PERMIT

A Repair

SEWAGE DISPOSAL SYSTEM

MARYLAND STATE DEPARTMENT OF HEALTH

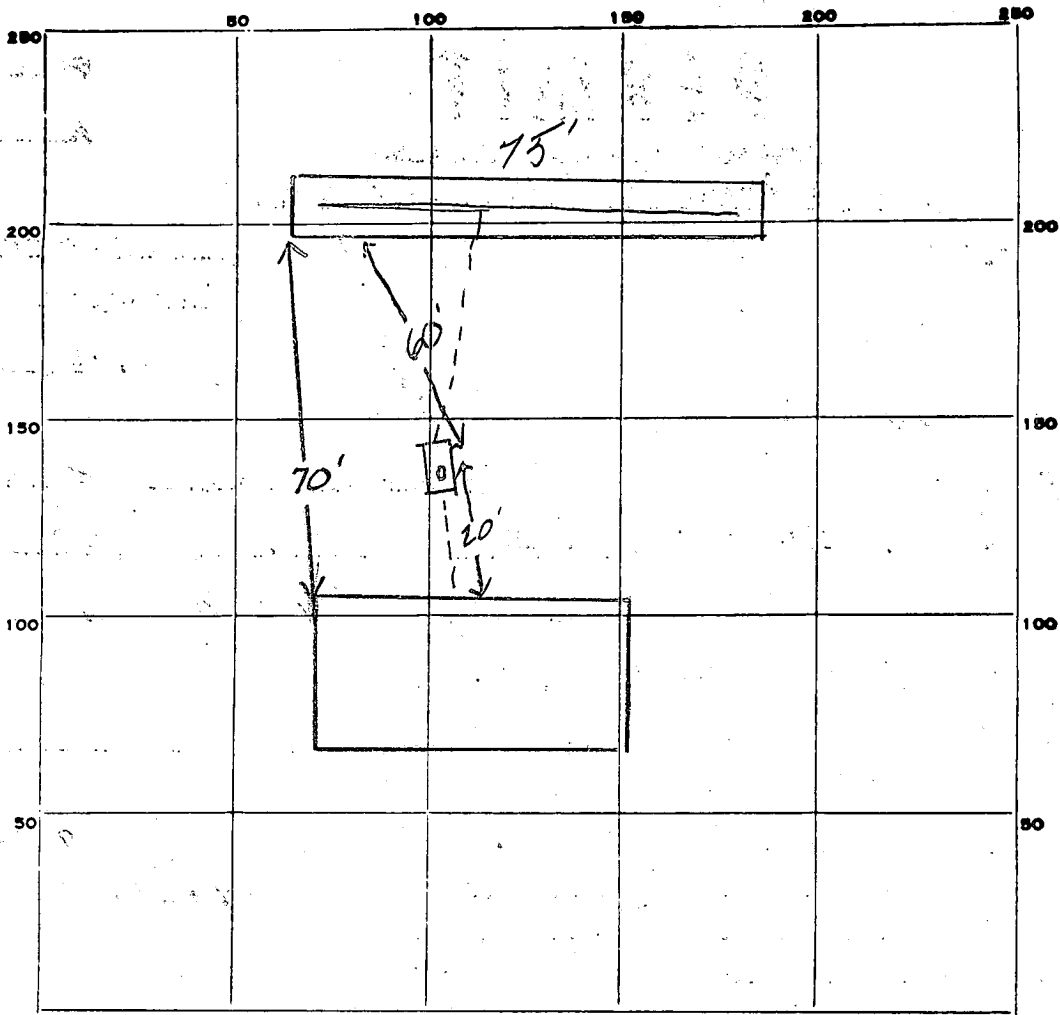
REPAIR - CALL FOR INSPECTION WHEN GROUND IS OPENED UP SO SANITARIAN CAN RECOMMEND

REPAIR: 70' trench, 4' wide, 4' deep, 2' stone, Disconnect old system SR 9-24-80 Inlet no deeper than 2 1/2' 9K 9-24-80
Replace any damaged pipe with cast iron 9K 9-24-80
